Official Transcript of Proceedings
NUCLEAR REGULATORY COMMISSION

Title: Advisory Committee on Reactor Safeguards
Open Session

Date: February 4, 2010

UNITED STATES OF AMERICA
NUCLEAR REGULATORY COMMISSION
+ + + + +
569th MEETING
ADVISORY COMMITTEE ON REACTOR SAFEGUARDS
(ACRS)

Figure 1

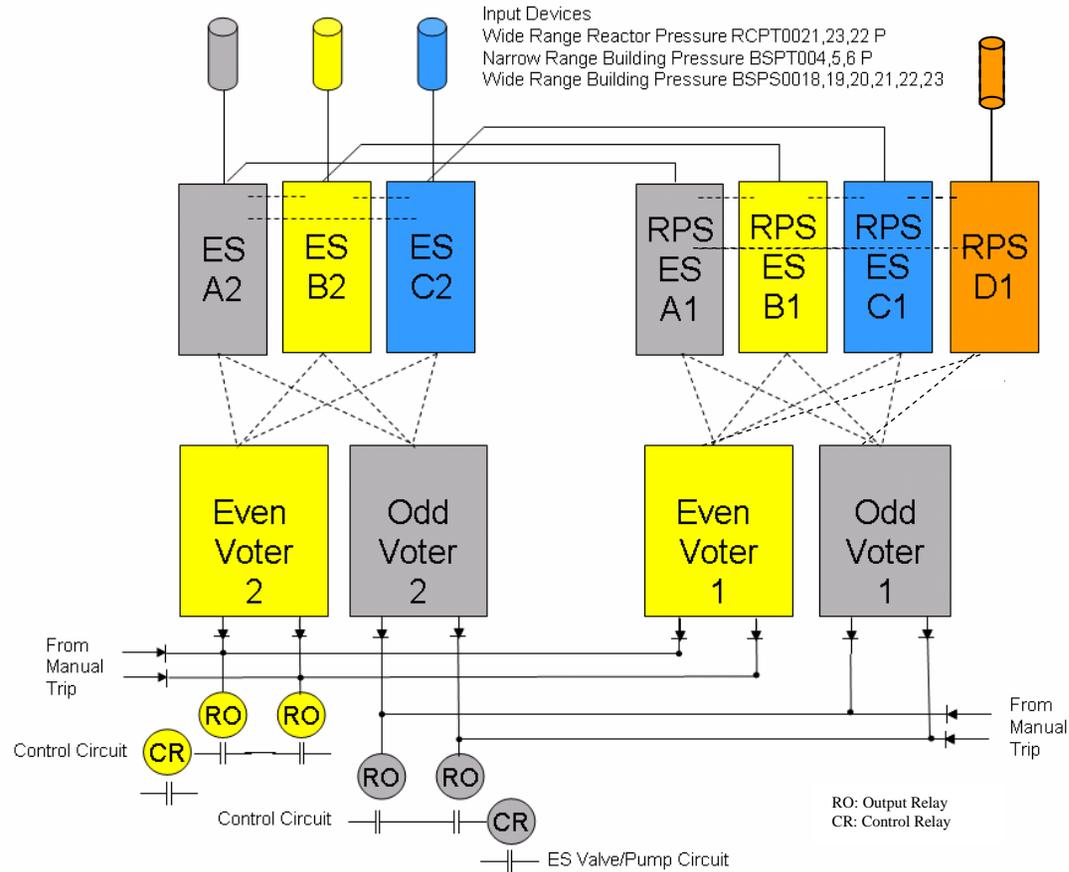
4 MR. NGUYEN: The second comment from the
5 public was how to accomplish Position 8, optional
6 single safety manual initiation that satisfies IEEE
7 603 and BTP 7-19?

2 In Figure 1, shown here, we have four
3 trains of the ESFAS, Engineered Safety Features
4 Actuation System and reactor protection system here.
5 And they are safety-related and the manual initiation
6 connected to the downstream of the system outputs
7 here. They're not connected upstream or before the
8 voters. So this will satisfy BTP 719.

As another example, the design of the Oconee Reactor Protection / Engineered Safety Features Actuation System features safety-related manual initiations (meeting IEEE Std 603 requirements) connected to the downstream of the system outputs (satisfying BTP 7-19) as shown in Figure 1.
